Form 3160-5
(June 2019)

SUNDRY NOTICES AND REPORTS ON WELLS
Do not use this form for proposals to drill or to re-enter an abandoned well. Use Form 3160-3 (APD) for such proposals.

EOG respectfully requests an amendment to our approved APD for this well to reflect the following changes:

Streetcar 15 Fed 304H (FKA 201H) API #: 30-025-47502

Revised Wellbore A:

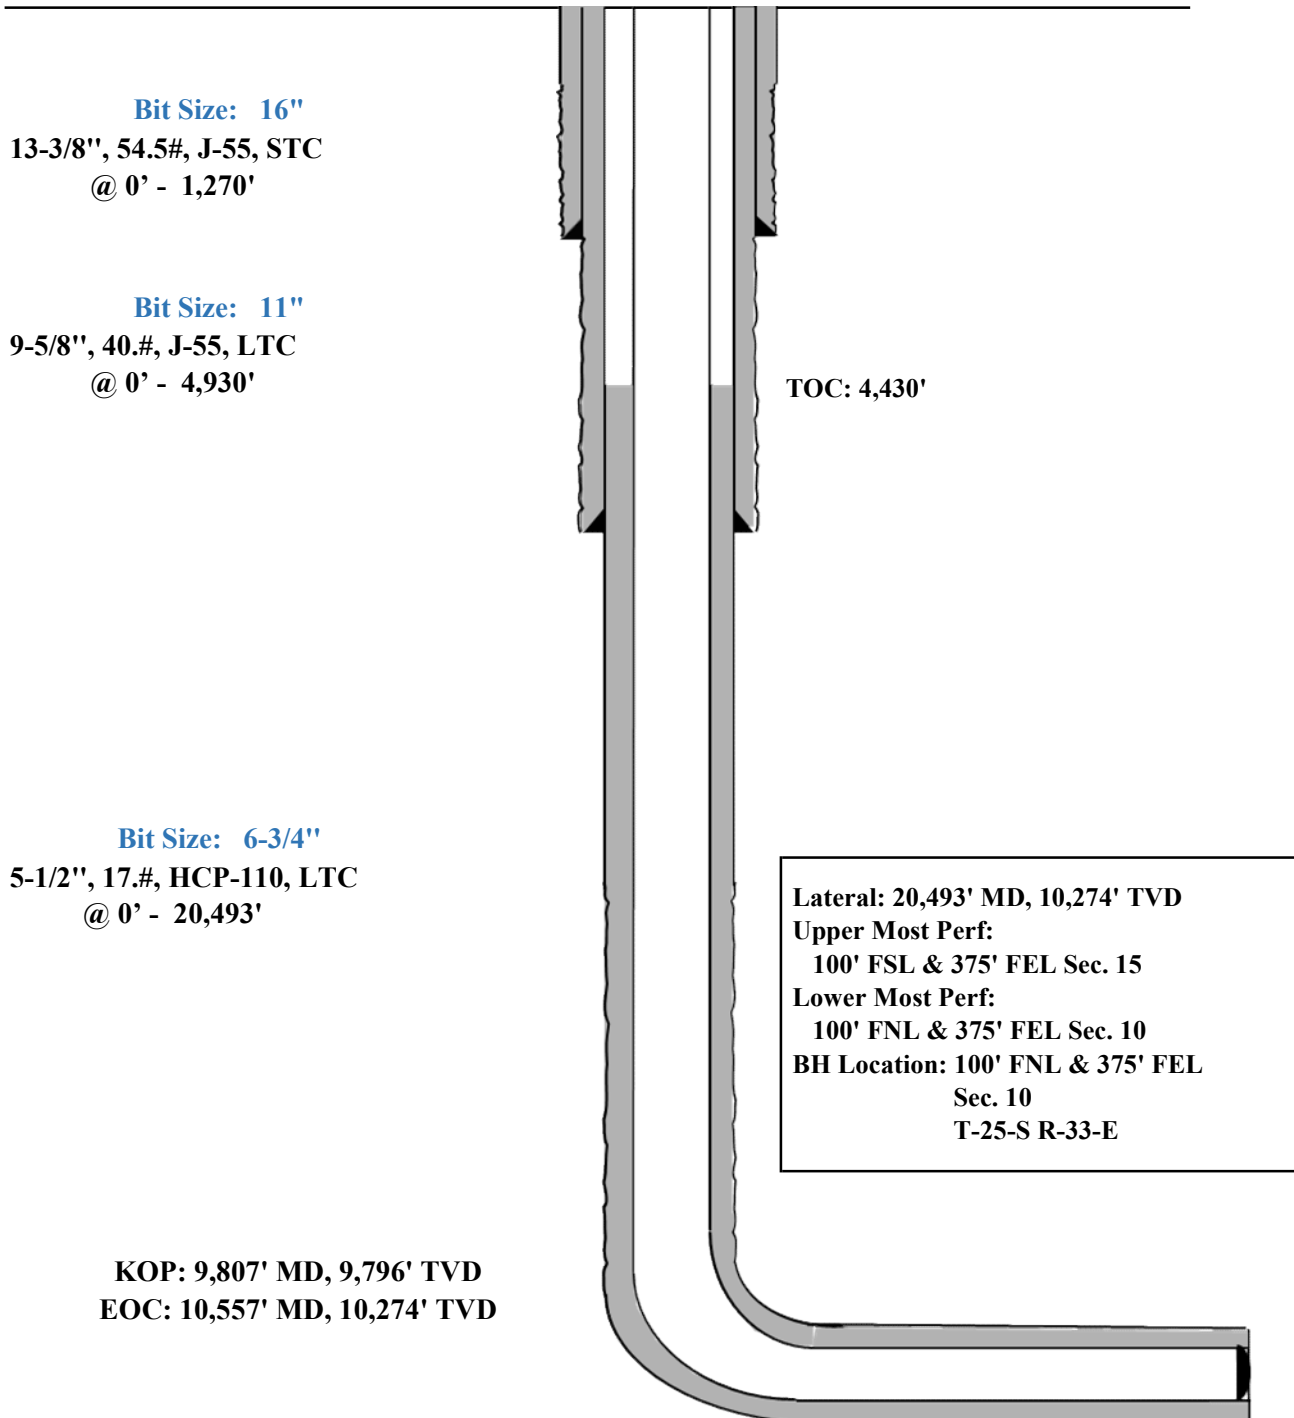
Casing Program A:

Hole Size	Interval MD		Interval TVD		Csg OD	Weight	Grade	Conn
	From (ft)	To (ft)	From (ft)	To (ft)				
16"	0	1,270	0	1,270	13-3/8"	54.5#	J-55	STC
11"	0	4,942	0	4,930	9-5/8"	40#	J-55	LTC
6-3/4"	0	20,493	0	10,274	5-1/2"	17#	HCP-110	LTC

Variance is requested to waive the centralizer requirements for the 9-5/8" casing in the 11" hole size. An expansion additive will be utilized, in the cement slurry, for the entire length of the 11" hole interval to maximize cement bond and zonal isolation.

Variance is also requested to waive any centralizer requirements for the 5-1/2" casing in the 6-3/4" hole size. An expansion additive will be utilized, in the cement slurry, for the entire length of the 6-3/4" hole interval to maximize cement bond and zonal isolation.

EOG requests permission to allow deviation from the 0.422" annulus clearance requirement for the intermediate (salt) section from Onshore Order #2 under the following conditions:

Revised Wellbore B:

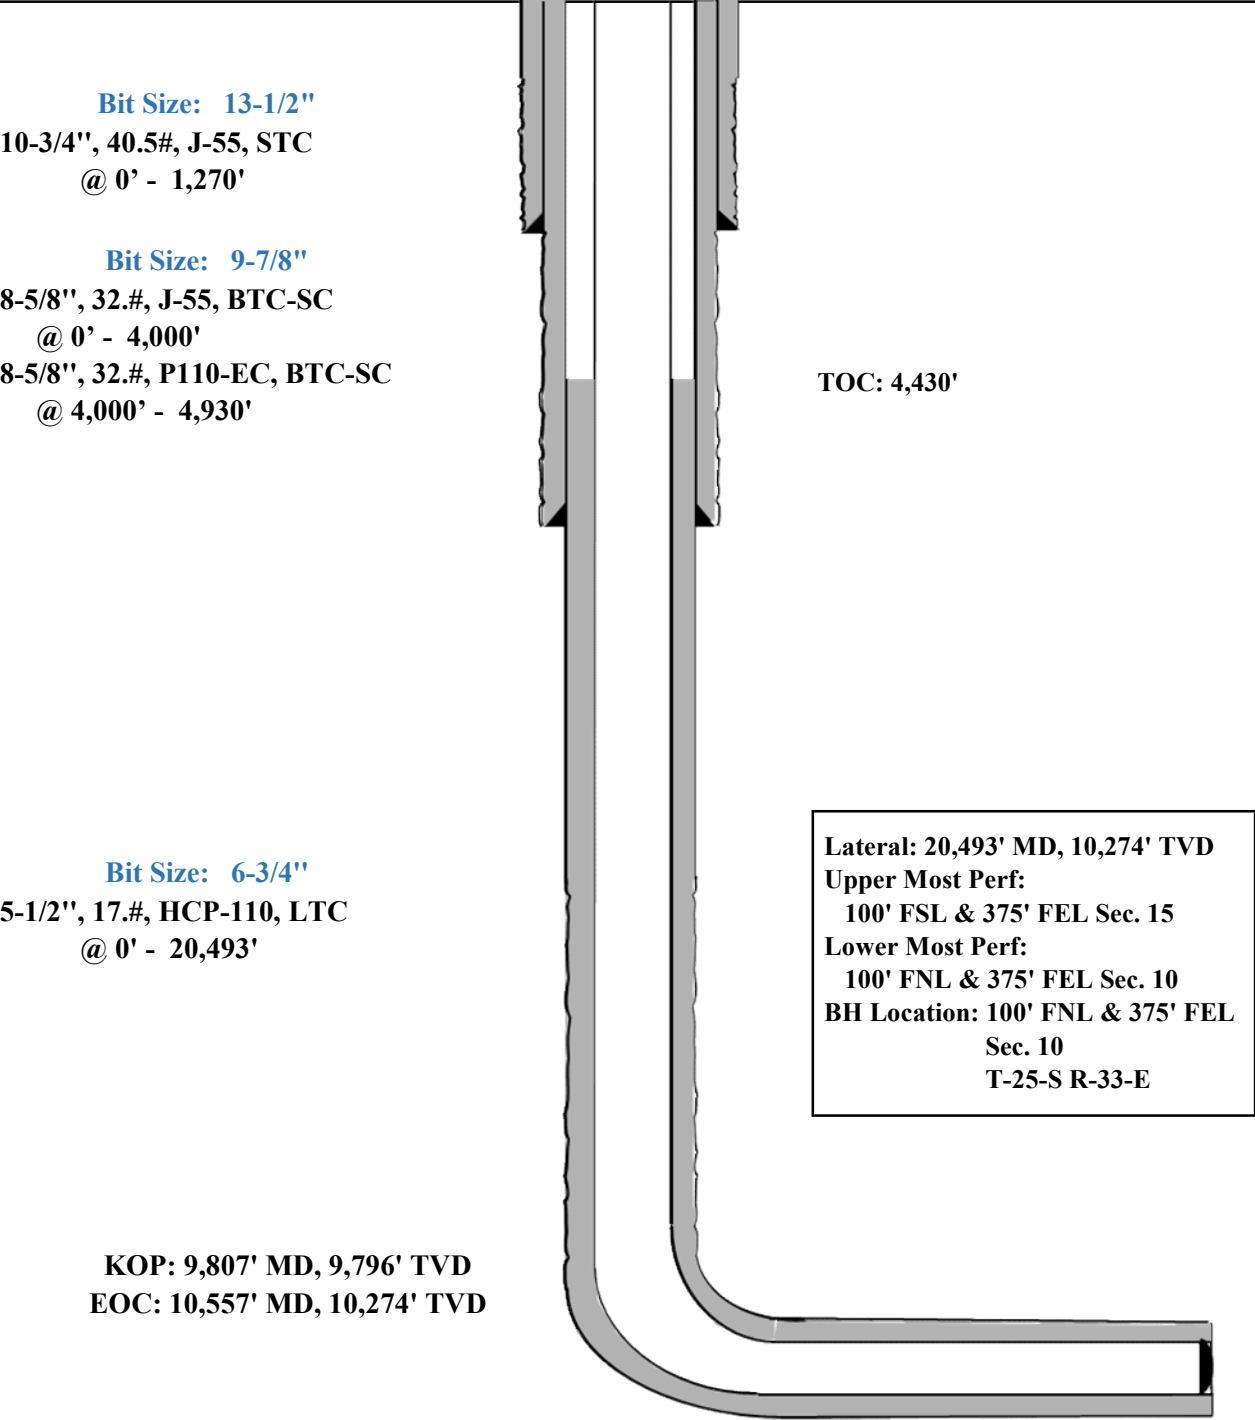
Casing Program B:

Hole Size	Interval MD		Interval TVD		Csg OD	Weight	Grade	Conn
	From (ft)	To (ft)	From (ft)	To (ft)				
13-1/2"	0	1,270	0	1,270	10-3/4"	40.5#	J-55	STC
9-7/8"	0	4,011	0	4,000	8-5/8"	32#	J-55	BTC-SC
9-7/8"	4,011	4,941	4,000	4,930	8-5/8"	32#	P110-EC	BTC-SC
6-3/4"	0	20,493	0	10,274	5-1/2"	17#	HCP-110	LTC

Variance is requested to waive the centralizer requirements for the 8-5/8" casing in the 9-7/8" hole size. An expansion additive will be utilized, in the cement slurry, for the entire length of the 9-7/8" hole interval to maximize cement bond and zonal isolation.

Variance is also requested to waive any centralizer requirements for the 5-1/2" casing in the 6-3/4" hole size. An expansion additive will be utilized, in the cement slurry, for the entire length of the 6-3/4" hole interval to maximize cement bond and zonal isolation.

EOG requests permission to allow deviation from the 0.422" annulus clearance requirement for the intermediate (salt) section from Onshore Order #2 under the following conditions:

Proposed 11" Hole with 9.625" 40# J55/HCK55 LTC Casing

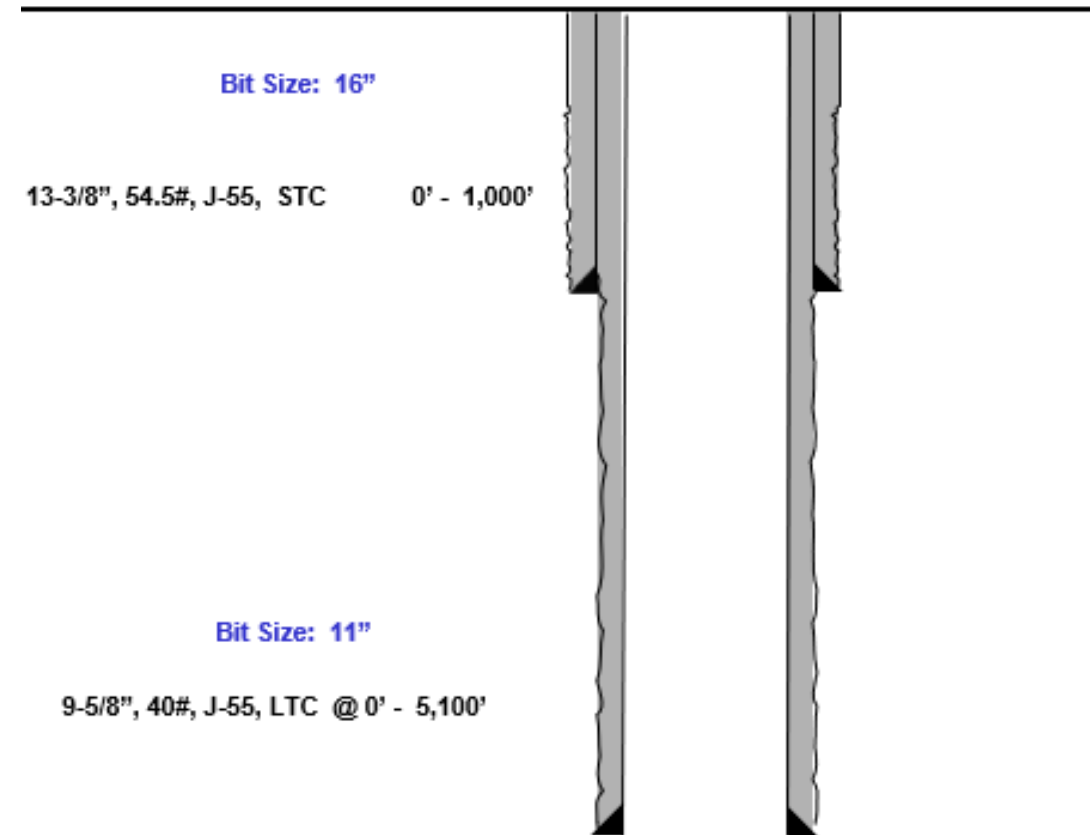
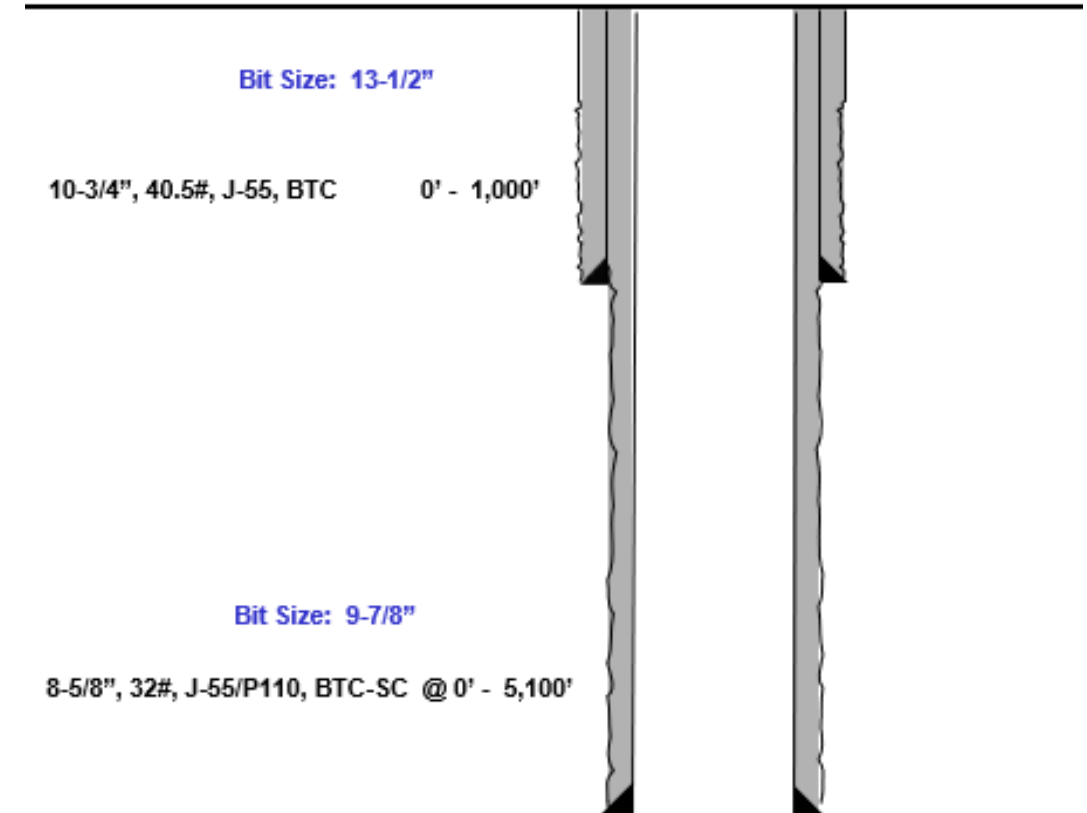
- 11" Bit + 0.52" Average hole enlargement = 11.52" Hole Size
 - 0.9475" Clearance to casing OD

$$= \frac{10.295 - 8.625}{2}$$
 - 0.585" Clearance to coupling OD

$$= \frac{10.295 - 9.125}{2}$$
- Previous Shoe – 10.75" 40.5# J55 STC
 - 0.4625" Clearance to coupling OD (~1,200' overlap)

$$= \frac{10.05 - 9.125}{2}$$
